REMARKS

The application has been reviewed in light of the Office Action mailed December 5, 2003. Claim 14 has been amended and new claims 20-24 have been added without adding new matter. Claim 6 has been cancelled. The specification and drawings have also been amended as explained below. Reconsideration of the application is requested in view of the following.

FIG. A

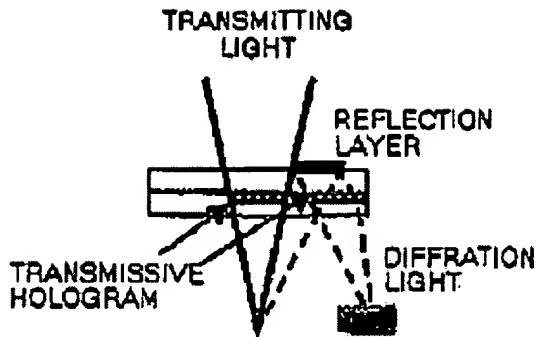
Moreover, the structure of the present invention offers advantages over the structure of Takeda. The present invention uses a transmissive hologram for obtaining both the signals from the optical medium and the monitor signals. See, for example, page 9, lines 39-45 of the specification. The transmissive hologram obtains signals of a disk through a process of diffracting the light reflected by the disk. In the present invention, as shown in Figure A below, the monitor signals are produced by transmissively diffracting the light in the transmissive hologram, after leading the reflection light from the reflection layer to the transmissive hologram. The hologram for the monitor signals exists on a surface different from the reflection layer, and not on the reflection layer, as shown in Figure B below.

FIG. 3B

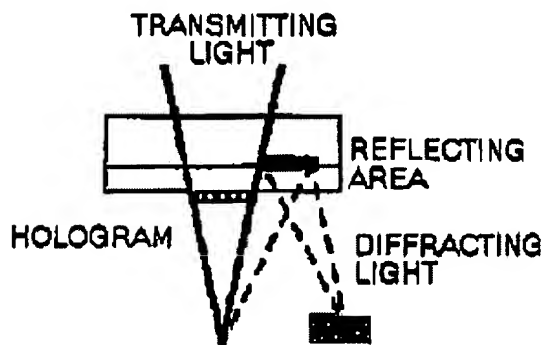
Takeda, on the other hand, obtains its monitor signal by reflection-diffracting light from a light source using a reflection hologram, rather than by a transmissive hologram. This is shown in Figure 3B of Takeda. As shown in figure 3C of Takeda, the hologram is formed on the surface of the reflection layer. Annotated versions of Figures 3B and 3C of Takeda are reproduced below. With Takeda, the holograms for obtaining disk signals and monitor signals have grooves with depths equal to each other. As a result, the respective transmissive and reflection holograms are not optimally provided with the grooves of different depths, and the holograms cannot produce optimal light amounts.
